Access Compliance Report

Public Rights-of-Way

(Curb Ramps)

Intersection ID: 11357	Main Street: W_TRADE_ST	Cross Street: N_IRWIN_AV	Location:	E
ADA ID: E1253579EB35	Ramp Type: Perp	Initial Pass/Fail: Fail	Overall Compliance: No	Severity Score: 12.5
Codes/Mitigation Info/Possible Solution		Field Measurements/Component Compliance

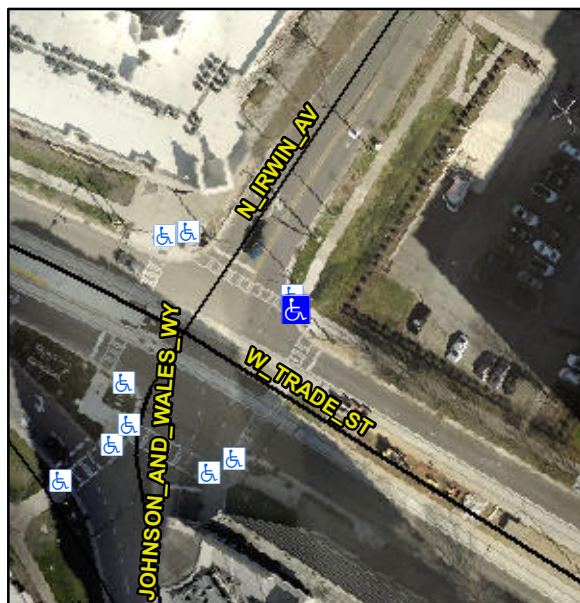
R304.5.3

Compliance	Description	Data	Compliance	Description	Data
N/A	Ramp Length (in)	62.0	Yes	Ramp Slope (%)	7.1
Yes	Ramp Width (in)	73.0	No	Ramp XSlope (%)	5.7
N/A	Flare Type LT	N/A	N/A	Flare Type RT	N/A
N/A	Flare Slope LT (%)	N/A	N/A	Flare Slope RT (%)	N/A
N/A	Flare Traversable LT?	N/A	N/A	Flare Traversable RT?	N/A
N/A	Landing Length (in)	N/A	N/A	DWS Provided?	N/A
N/A	Landing Width (in)	N/A	N/A	DWS Contrast?	N/A
N/A	Landing Slope (%)	N/A	N/A	DWS Length (in)	N/A
N/A	Landing X Slope (%)	N/A	N/A	DWS Full Width?	N/A
N/A	Landing Curb? (Y/N)	N/A	N/A	DWS Offset (in)	N/A
N/A	Shared Landing?	N/A			
N/A	Gutter Ponding?	N/A	N/A	Gutter Slope (%)	N/A
N/A	Gutter Lip Ht (in)	N/A	N/A	Gutter X Slope (%)	N/A
N/A	Painted X Walk1?	Yes	N/A	Painted X Walk2?	N/A
	X Walk 1 Direction	To SW		X Walk 2 Direction	N/A
N/A	X Walk 1 Width (in)	75.0	N/A	X Walk 2 Width (in)	N/A
	X Walk 1 Slope (%)	0.6		X Walk 2 Slope (%)	N/A
	X Walk 1 X Slope (%)	5.2		X Walk 2 X Slope (%)	N/A

Remove & Replace Entire Ramp.
